REVISED RESPONSE TO REQUEST FOR ADDITIONAL INFORMATION

APR1400 Design Certification

Docket No. 52-046

RAI No.: 114-8041
SRP Section: 03.04.01 – Internal Flood Protection for Onsite Equipment Failures
Application Section: 3.4.1
Date of RAI Issue: 07/27/2015

Figure 3 Flow Opening Schematic drawing on El. 100 ft

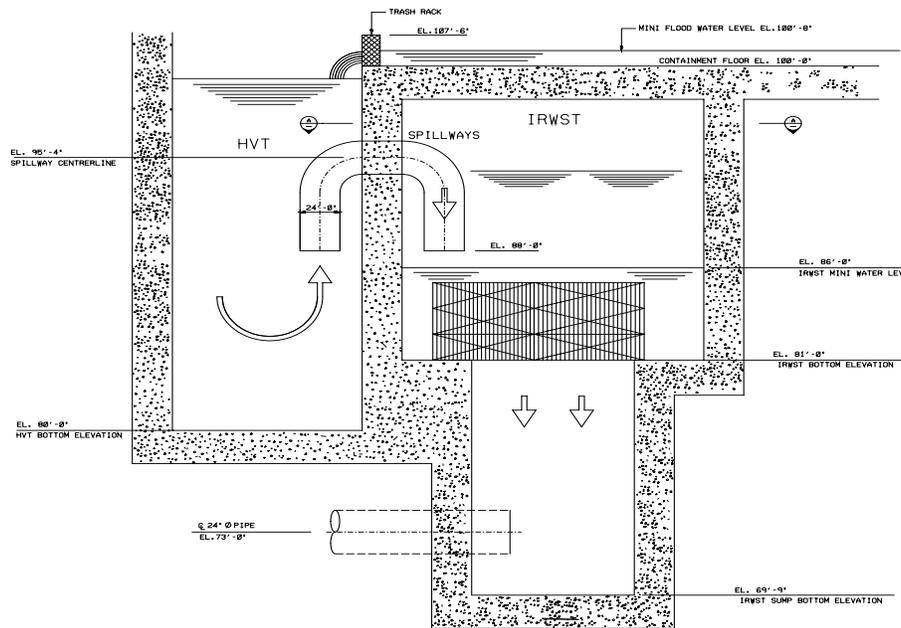
- a) Provide a comprehensive explanation of the calculation method for using “maximum break”, instead of “maximum flood water volume” to determine the worst case flooding event. In general, flood level is determined by the water volume. Provide design requirements (such as the drain capability) and the basis to support the method being used by APR1400.

- c) Explain how other in-containment water sources (such as main feedwater line, main steam line, auxiliary feedwater system, shutdown cooling system, component cooling system, safety injection tank (SIT), and other water carrying piping) compare against the worst case LOCA?

The flowrate through the opening is generally calculated by using the weir equations as depicted in Table 2 below. The shape of floor openings at EL.100 ft is similar to the sharp-crested rectangular and broad-crested rectangular weirs from Figures 1 through 3; thus, the associated equations are appropriate to use to calculate the flow rate in APR1400 DC.

The swirling effect is considered negligible since the floor opening width is sufficiently large and the flood source due to a FW line break would flow to EL.136 ft, down to EL.114 ft and finally to EL.100 ft of the containment building through gratings or stairwells. Thus, the flow rate will be decreasing such that the swirling effect is not significant.
